Hot Spot Areas 1,1A and 2
Work Plan
Revision 1

Enviro-Chem Site
Zionsville, Indiana

Review Comments on Environ's *Response to Hot Spots Areas 1, 1A and 2 Work Plan Comments* letter dated December 20, 1999

RE: Response to Hot Spot Areas 1, 1A and 2 Work Plan Comments
Enviro-Chem Superfund Site, Zionsville, Indiana

**FIGURE 1
HOT SPOT
SITE MAP**

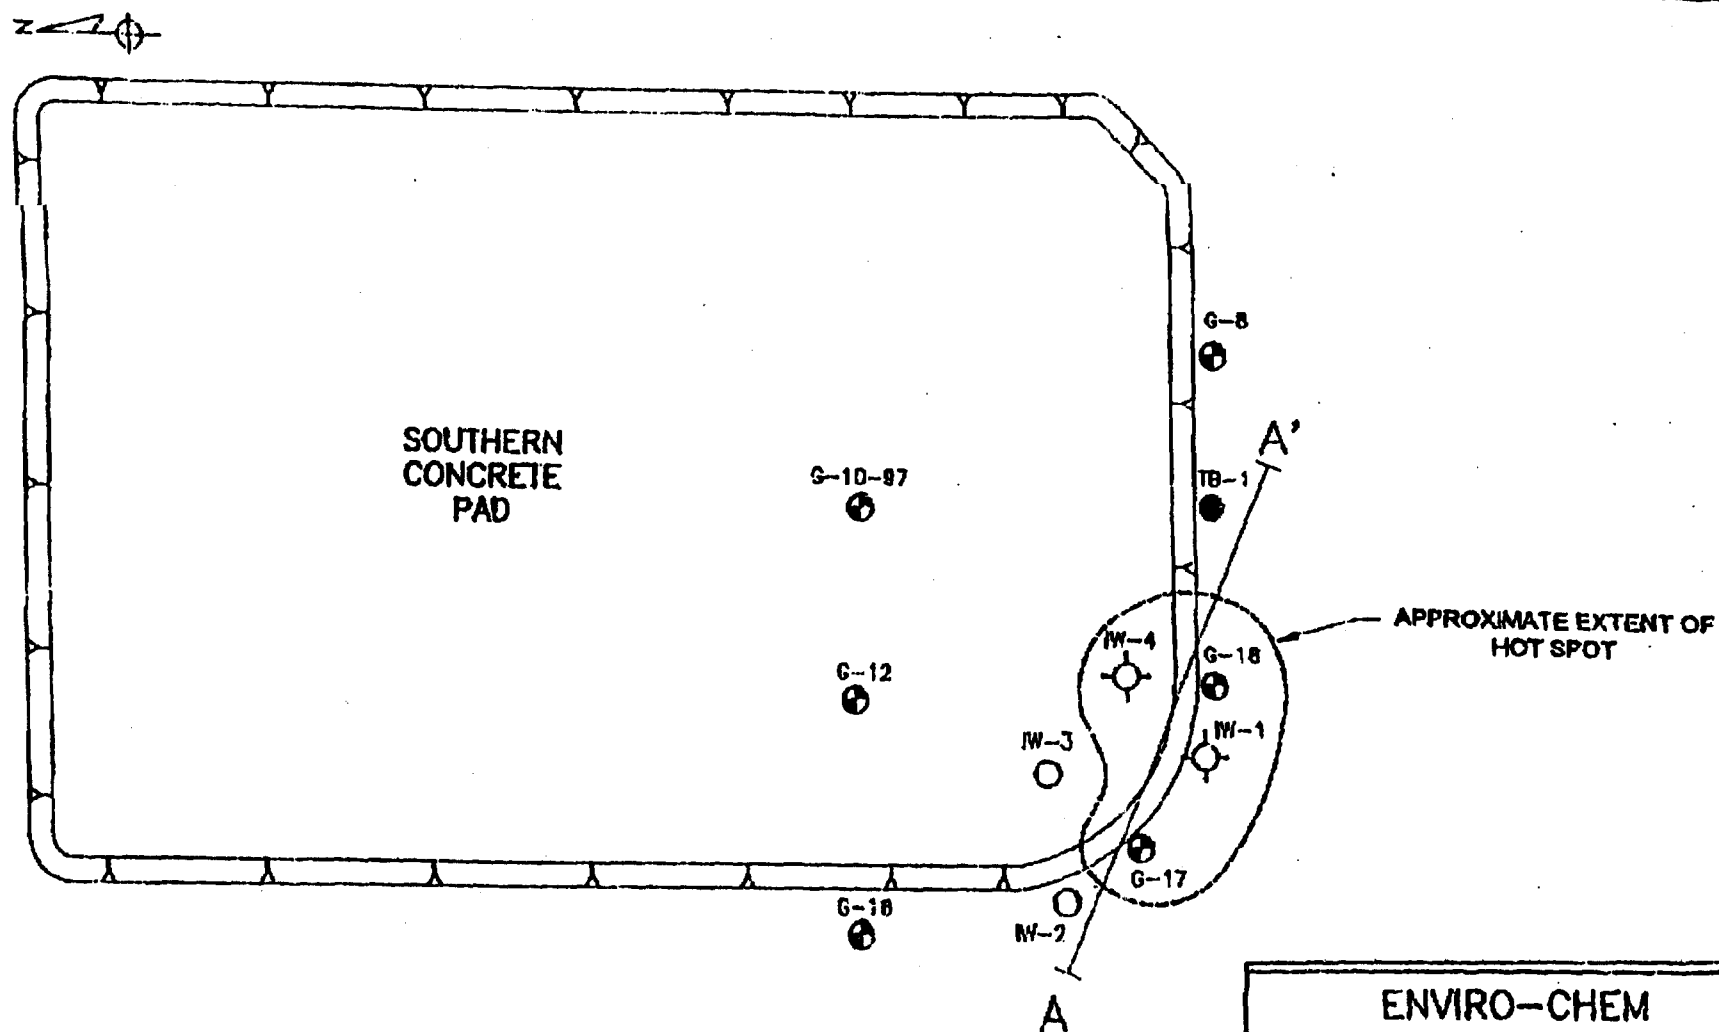
The area considered for further delineation is presented in Figure 1 of Appendix F of the Work Plan, Versar’s Preliminary Hot Spot Report. The Geoprobe locations will be selected around the estimated extent of the Hot Spot. If screening samples indicate that
